PLANNING DIVISION STAFF REPORT

Project Address: 114 Milky Way (3rd Aldermanic District – Ald. Hall)
Application Type: Conditional Use
Legistar File ID # [43422](#)
Prepared By: Chris Wells, Planning Division
Report Includes Comments from other City Agencies, as noted
Reviewed By: Jay Wendt, Principal Planner

Requested Action: Consideration of a conditional use to construct a residential building complex with 94 units in six buildings at 114 Milky Way.

(Figure 1: Diagram of the relationship of the proposed project site and the nearest daily, all-day Metro stop)

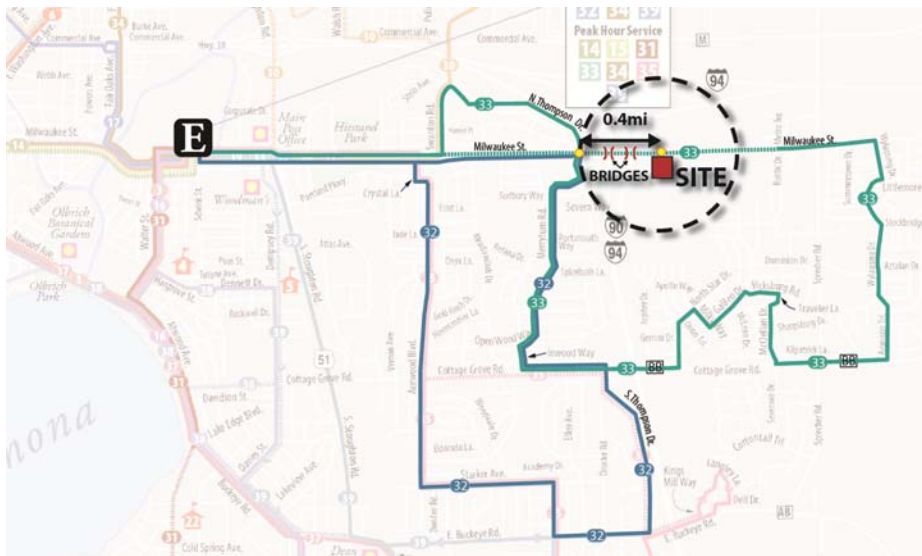
Metro is concerned with the lack of adequate pedestrian infrastructure between the proposed development and the nearest bus stop with daily, all-day service located 0.4-miles west across Interstate 90 at the South Thompson Drive intersection with Milwaukee Street. East of the Interstate, Milwaukee Street currently does not have a sidewalk on either side of the road. Metro however, is most concerned with any pedestrian faced with having to cross either of the two Interstate 90 bridge overpasses (please see the diagram below). The eastern bridge is approximately 200-feet long while the western bridge approximately 250-feet and neither have even a painted white line indicating a shoulder of any width. Wisconsin Department of Transportation has indicated that they plan to restripe both bridges sometime in 2018, thereby shrinking the width of the travel lanes from roughly 13-feet to 10-feet and creating a 5-foot shoulder in each direction.
